Work Order ID 139297

Item Name: Quick Release Heli-Utility-Basket™ Long, HD Lid, Spacepod™/Squirrel Cheek Comp.

DART SERVICE INSTRUCTION

TO AMEND INSTALLATION INSTRUCTIONS D350-607-3 Rev.D,
INSTALLATION INSTRUCTIONS D350-607-4 Rev. C AND
INSTRUCTIONS FOR CONTINUED AIRWORTHINESS ICA-D350-607 REV. 6

FIGURE 1: INSTALLATION OF D4775-041 FWD STRUT

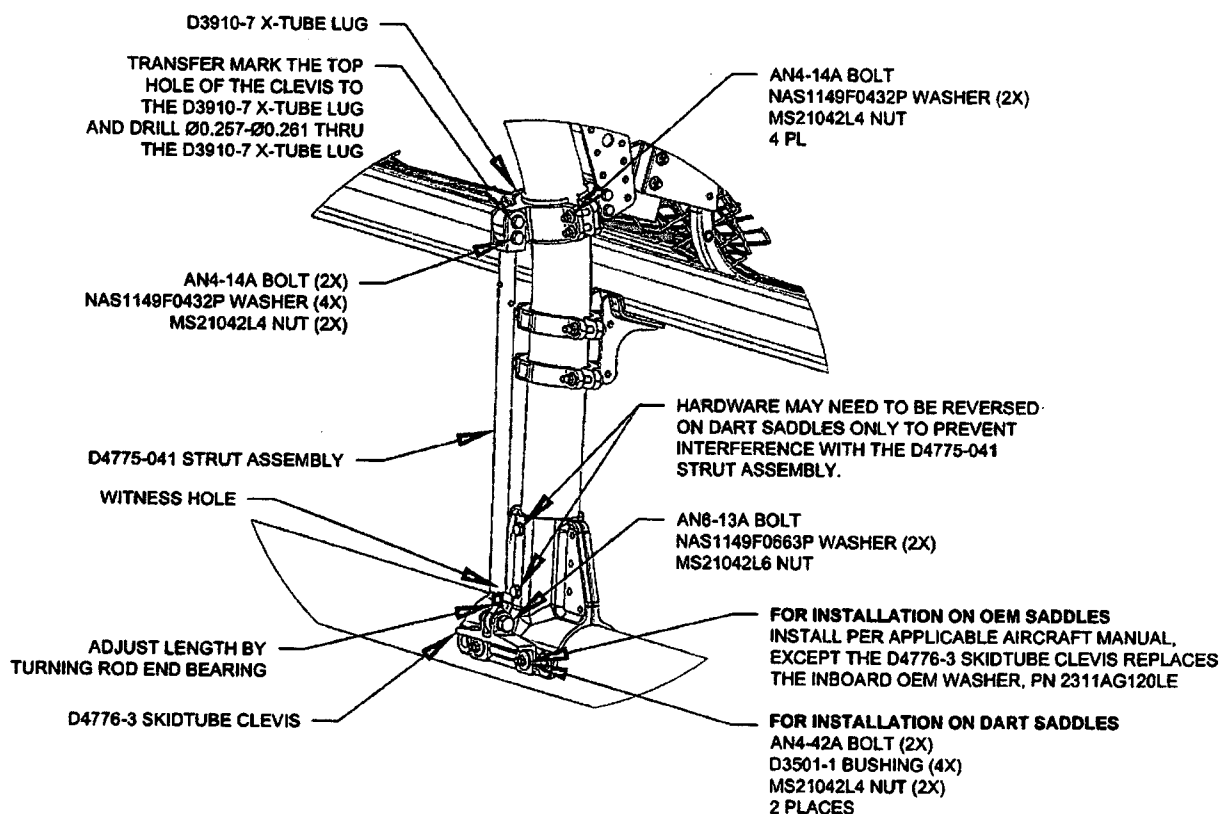
- 3.1 Substitute the Forward Lower D3910-5 X-Tube Lug with the D3910-7 X-Tube Lug as shown in Figure 1.
- 3.2 Install the forward D4775-041 Strut Assembly. Transfer mark from the upper hole on the clevis of the D4775-041 Strut Assembly to the D3910-7 X-tube Lug and drill thru the lug $\varnothing 0.257 - \varnothing 0.261$ as shown in Figure 1. Touch up chemical conversion coating per MIL-DTL-5541. Check the witness holes located at the bottom end of the D4775-041 Strut Assemblies to ensure that the thread from the rod end extends past the witness hole.
Torque MS21042L4/-4 nuts to 50-70 in-lbs (5.7-7.9 N-m). Torque MS21042L6/-6 nuts to 160-190 in-lbs (18.1-21.5 N-m).
- 3.3 Complete the installation in accordance with Installation Instructions D350-607-3 Rev. D or D350-607-4 Rev. C.
